COMMUNITY DEVELOPMENT DEPARTMENT REPORT

HEARING DATE: 12/16/2025

SUBJECT: H-2024-0061
Apex Cadence (aka Pinnacle) – ALT,
MDA, PUD, PP, RZ, PS

G. Preliminary Plat (dated: ~~10/9/24~~ 11/19/2025 12/08/2025) & Phasing Plan

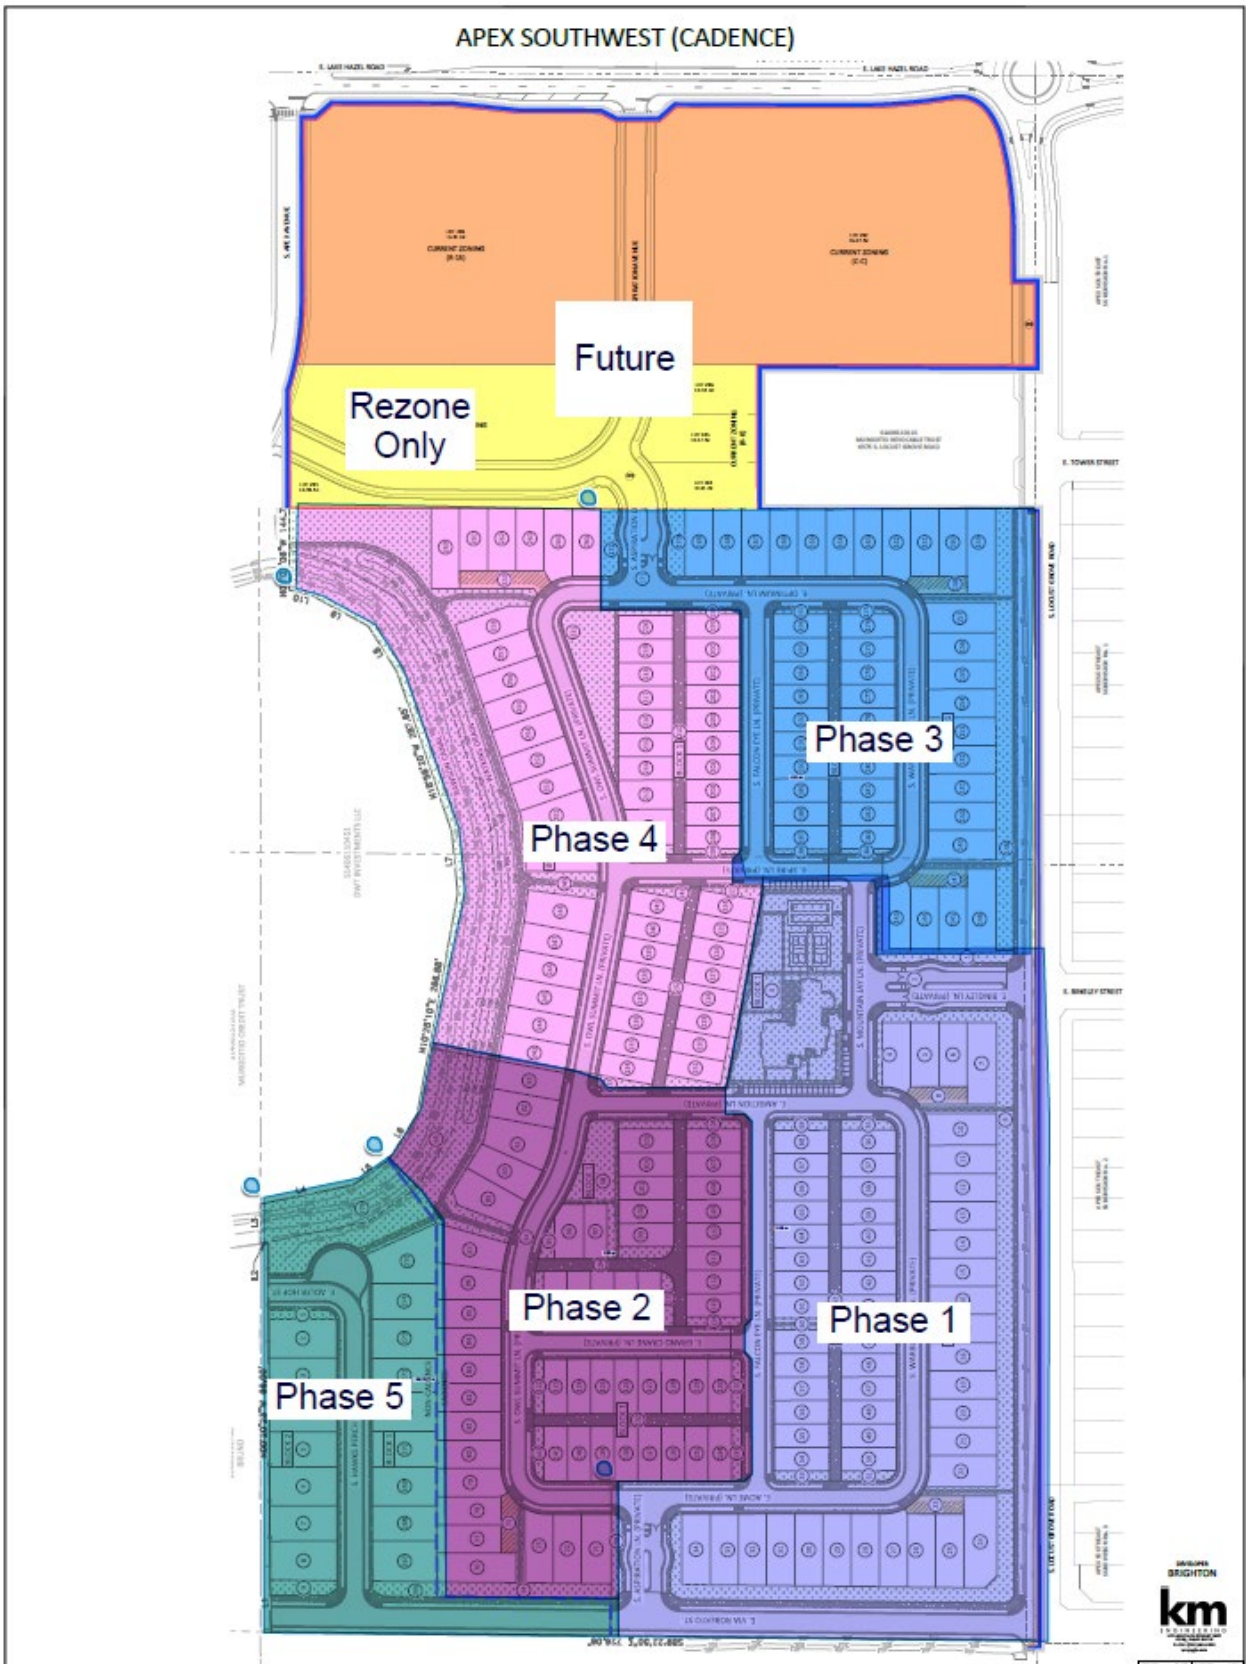
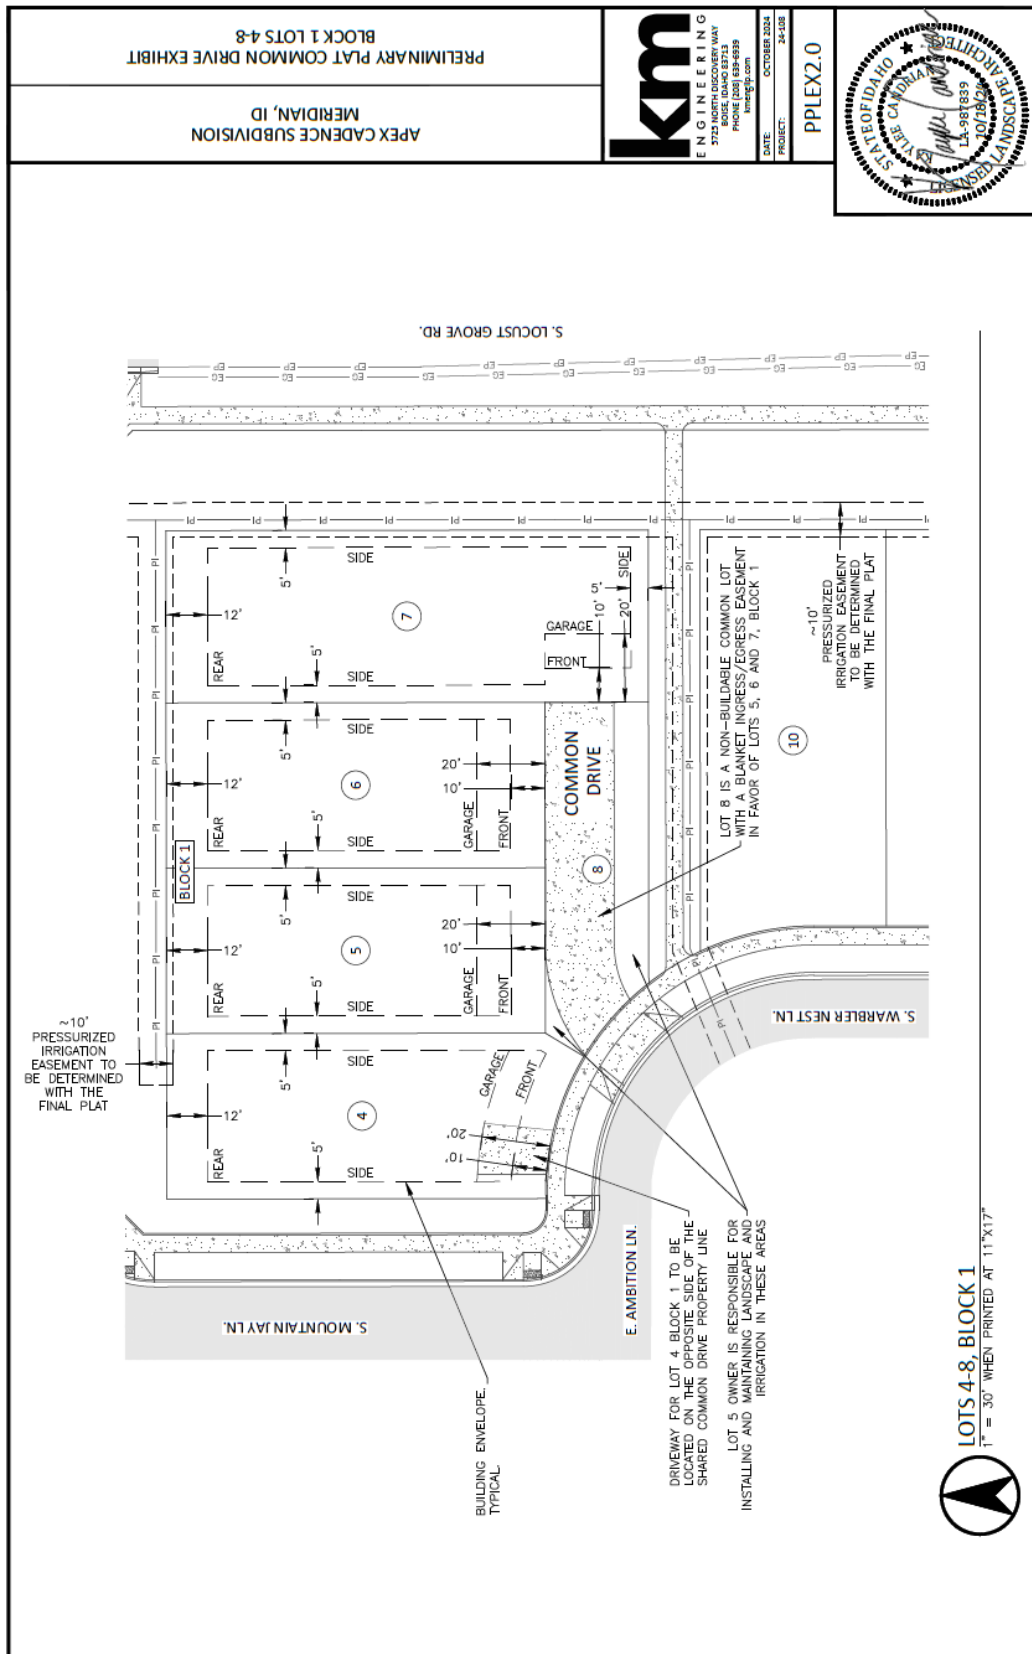
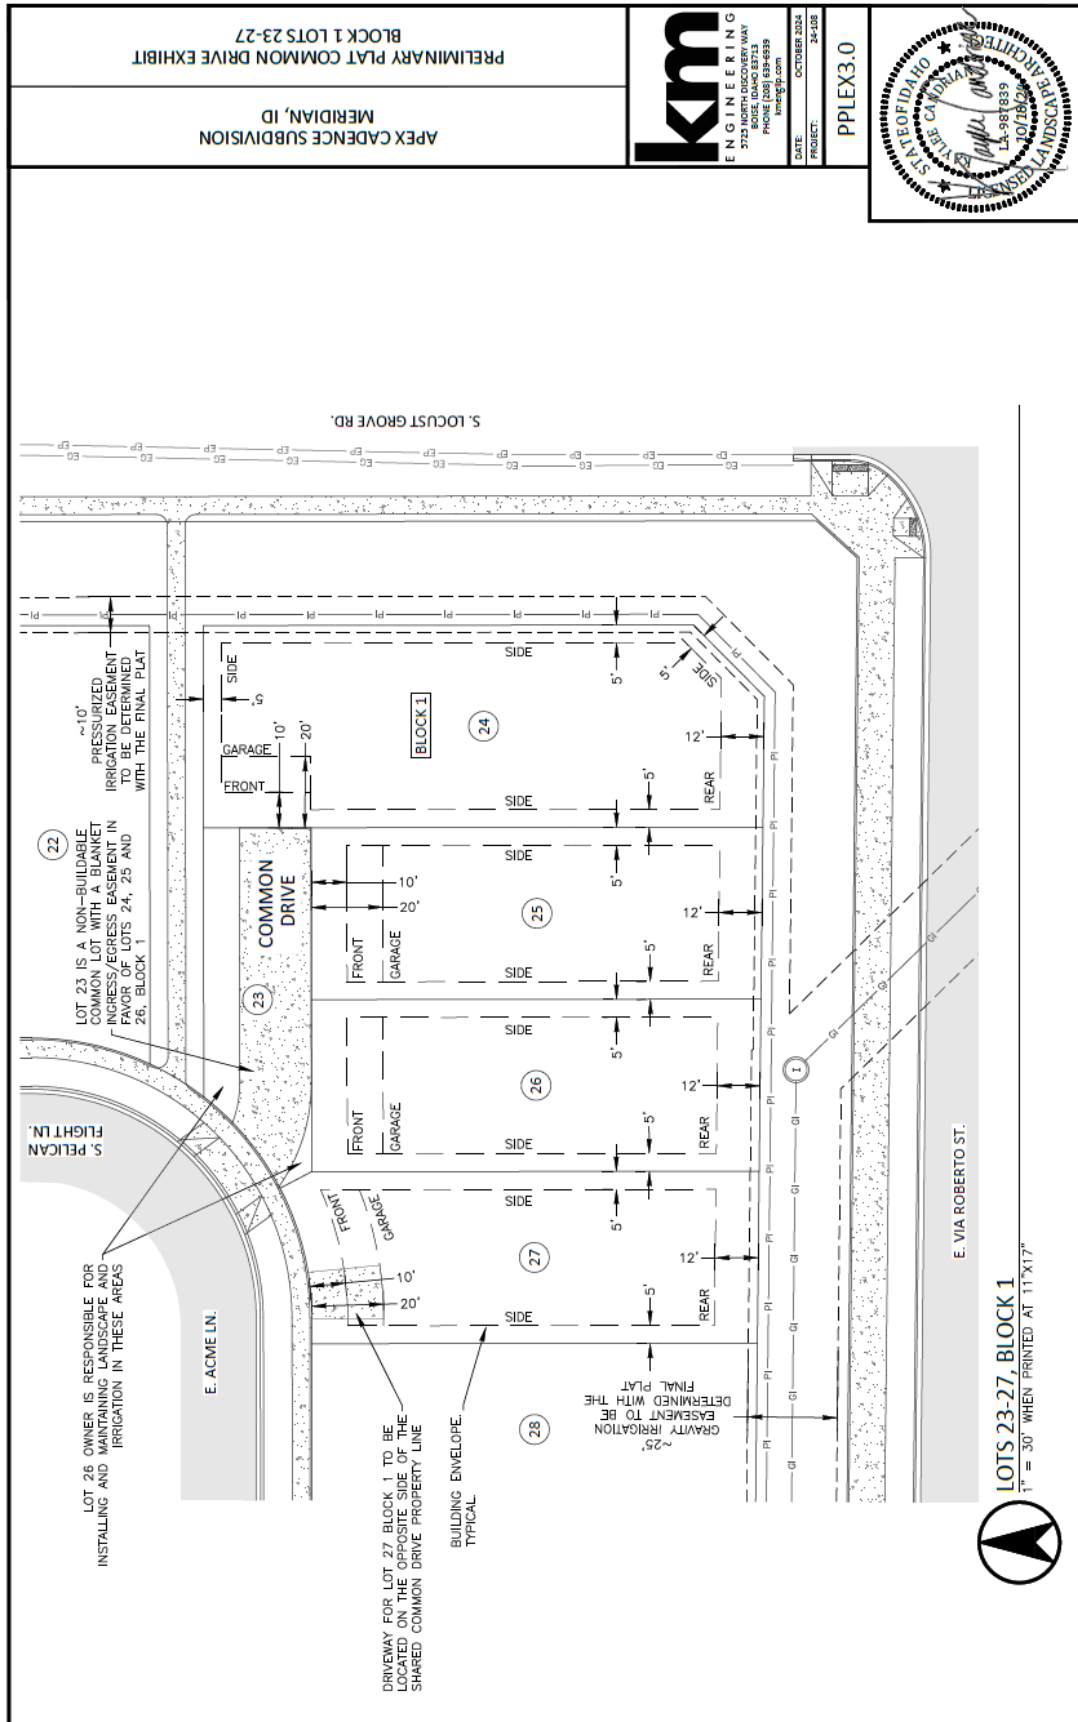
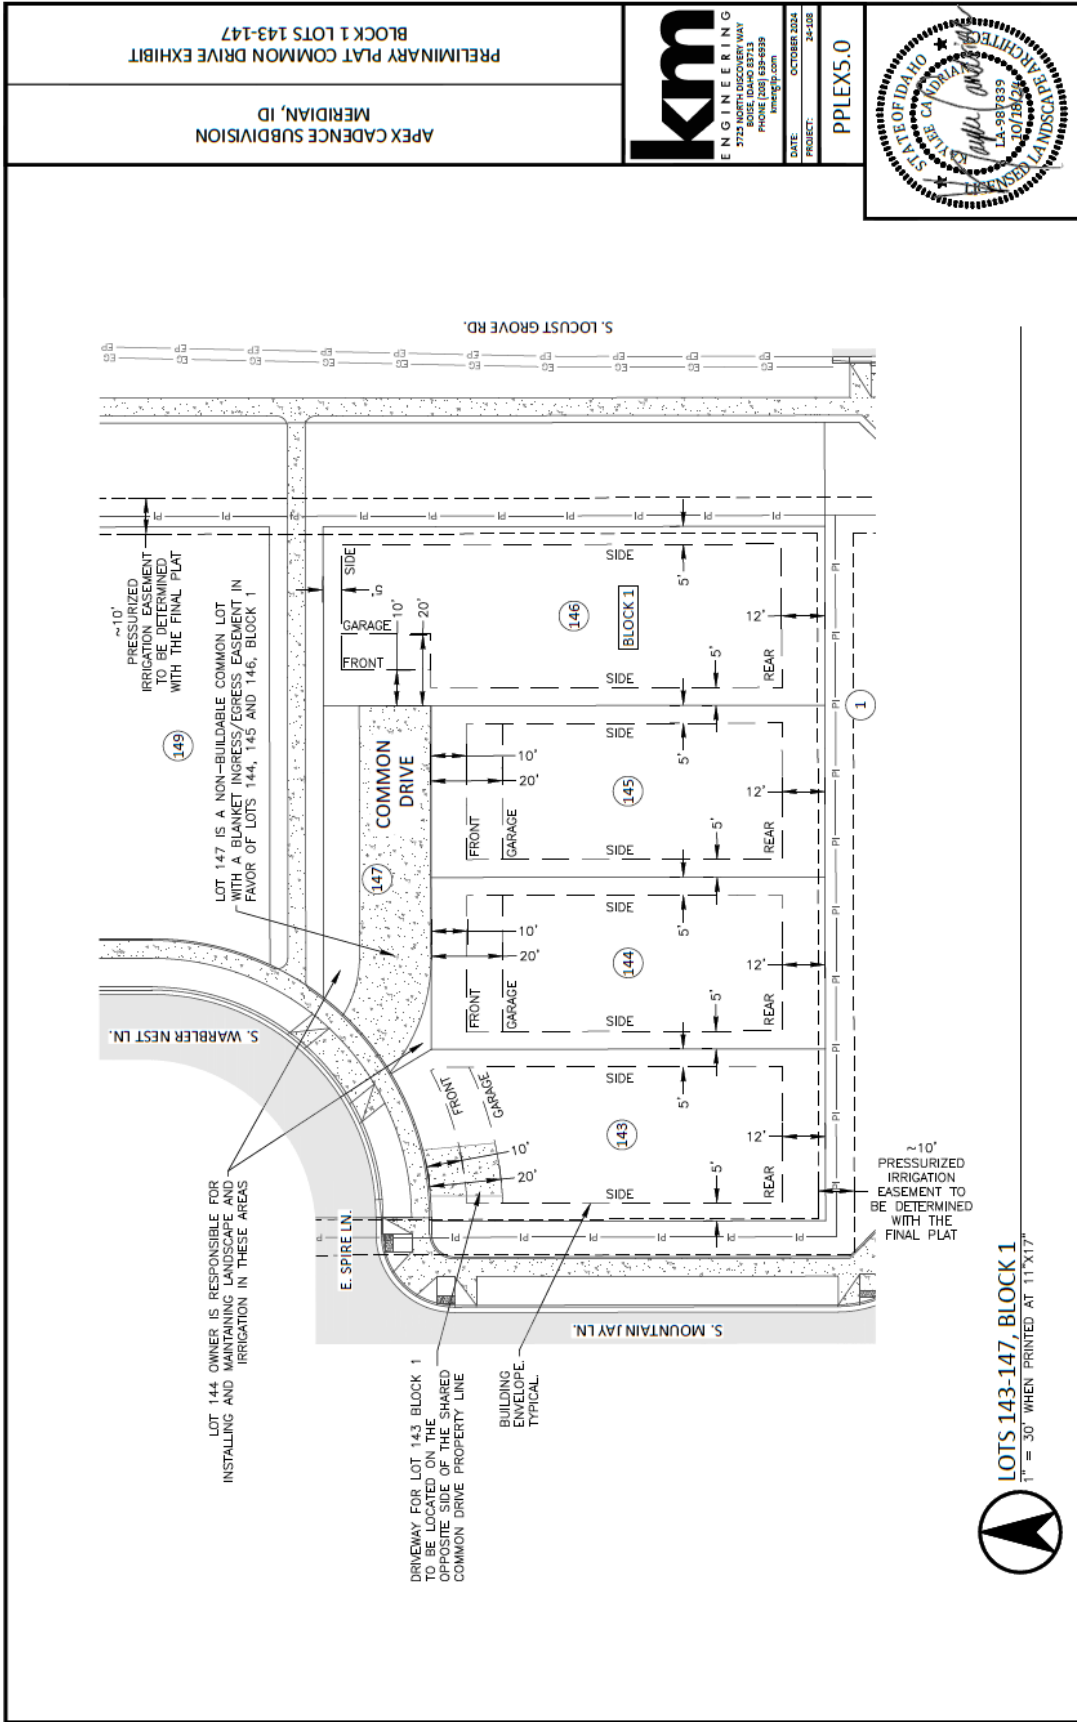
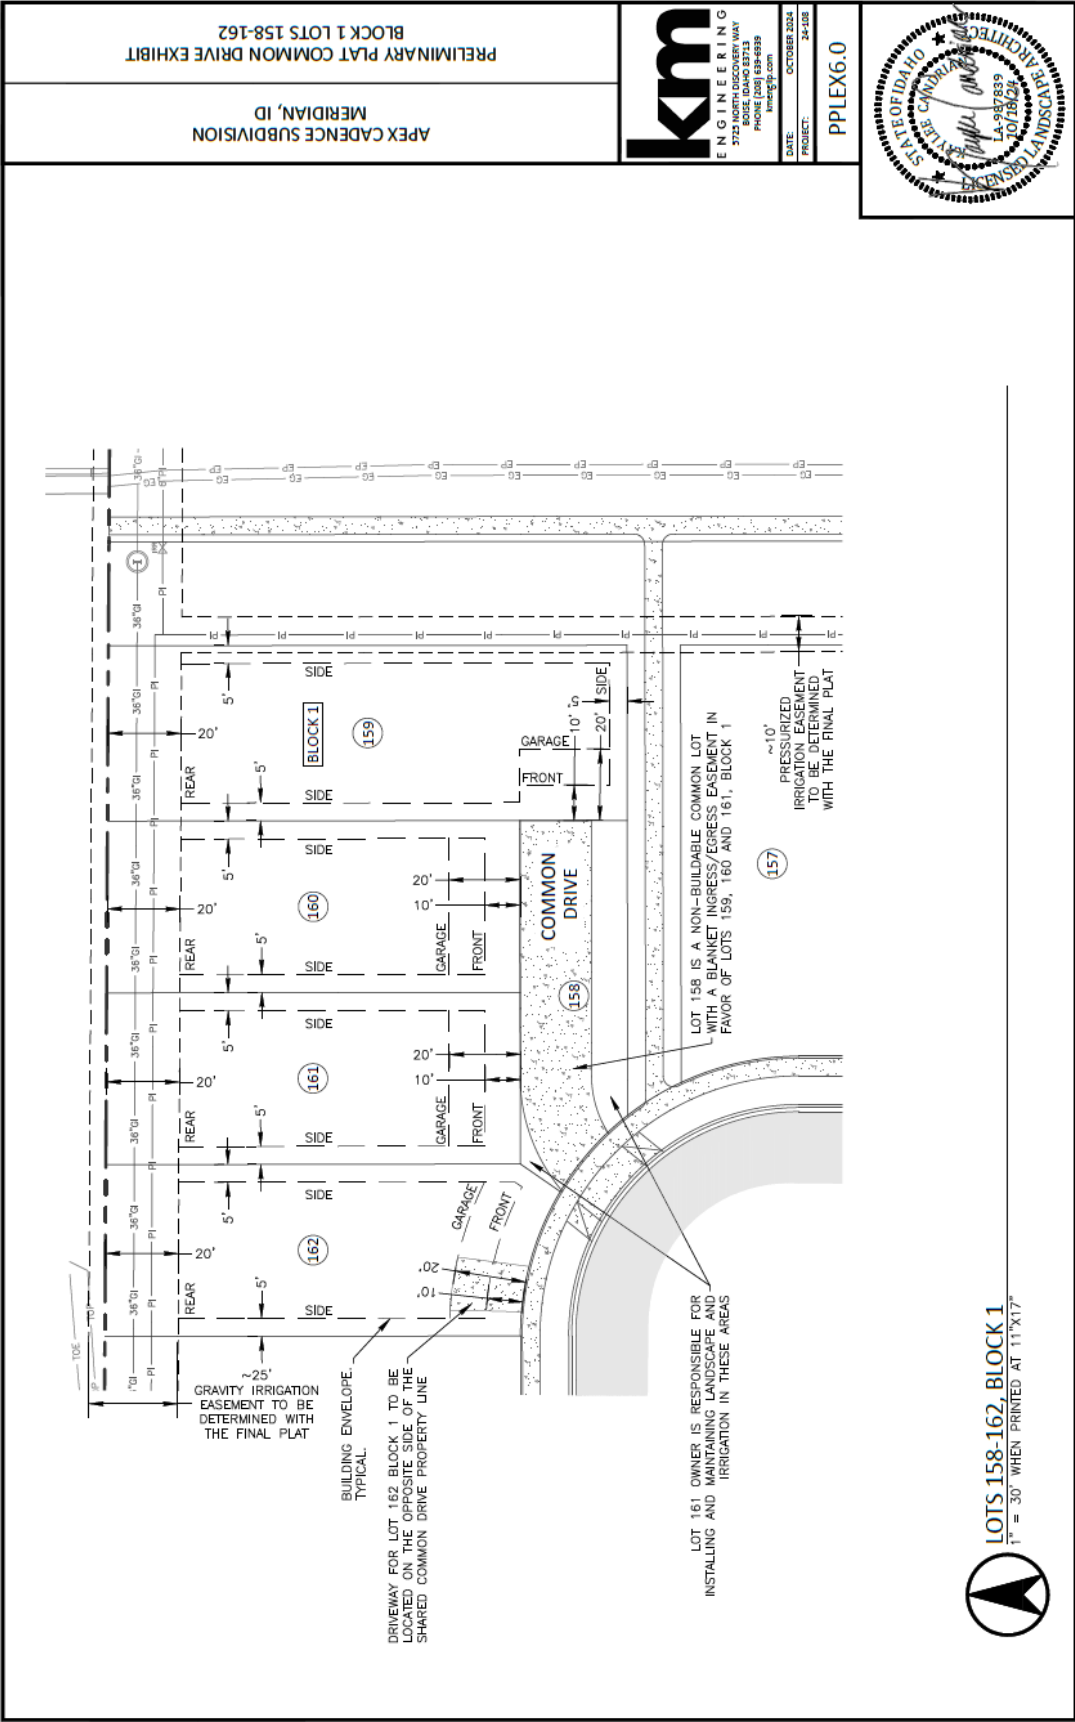
Alleys are required to comply with the standards in UDC 11-6C-3B.5. The proposed 20-foot-wide alley street sections depicted on the plat comply with these standards. A turning radius exhibit was submitted that demonstrates the entrance to the alleys from the private streets provide a minimum 28-foot inside and 48-foot outside turning radius as required by the Fire Dept. **Wayfinding address signage should be provided at the private street for homes accessed via alleys that don't have frontage on a named street (i.e. Lots 96, 97, 99-103, Block 1 and Lots 224-231, Block 1).**

The Watkins Drain bisects this site north/south and is being relocated along the Rawson Canal and will either be piped or remain open per the preliminary engineering plans; **the easement should be depicted on the plat.**

- vi. Remove one (1) of the building lots within the area of Lots 260-263, Block 1 to comply with UDC 11-6C-3D.1, which allows a maximum of three (3) dwelling units to be located one (1) side of the common driveway.

- xii. Depict private streets on a single platted lot that provides access to all properties served by such private streets.
- b. The landscape plan shall include the following revisions:

**LOTS 158-162, BLOCK 1**
1" = 30' WHEN PRINTED AT 11"x17"

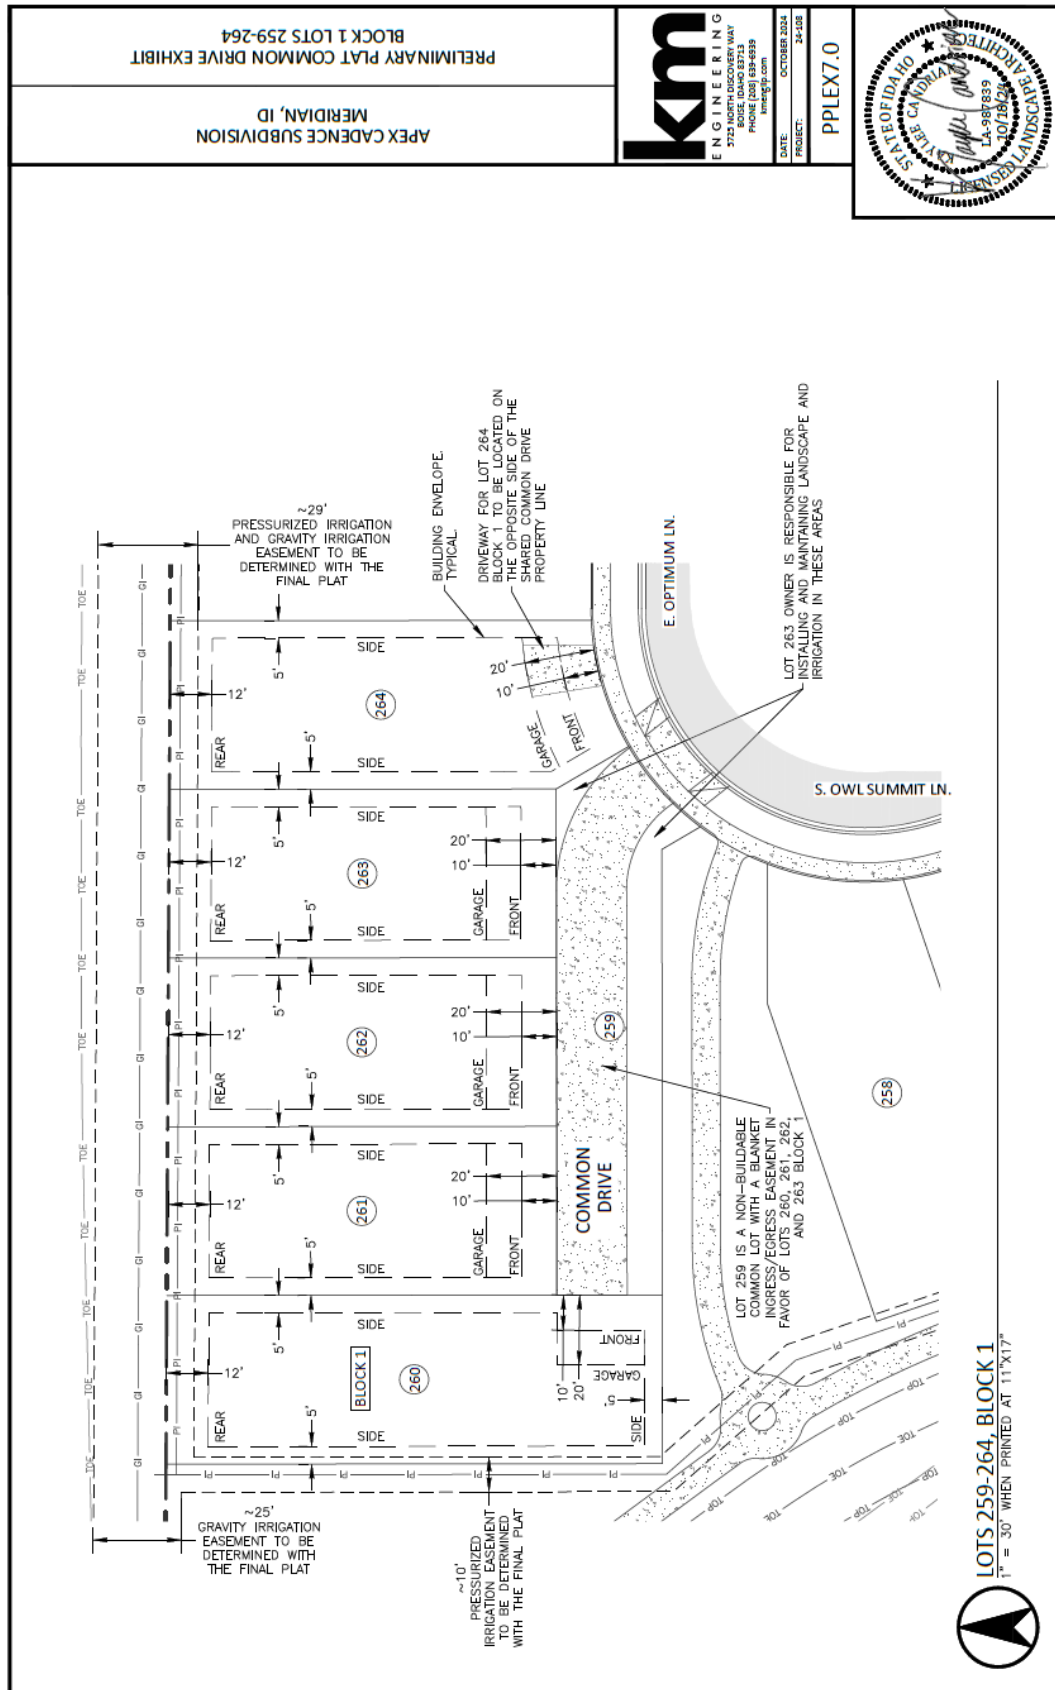
- ~~v. Include the small triangle areas depicted on the landscape plan and common driveway exhibits between the common driveways and adjacent building lots in the adjacent building lots. Ensure the driveways provide a 28-foot inside and 48-foot outside turning radius in accord with UDC 11-6C-3D.6.~~

- g. The common driveways shall be constructed in accord with the standards listed in UDC 11-6C-3D and the revised common driveway exhibits in Section VII.H.
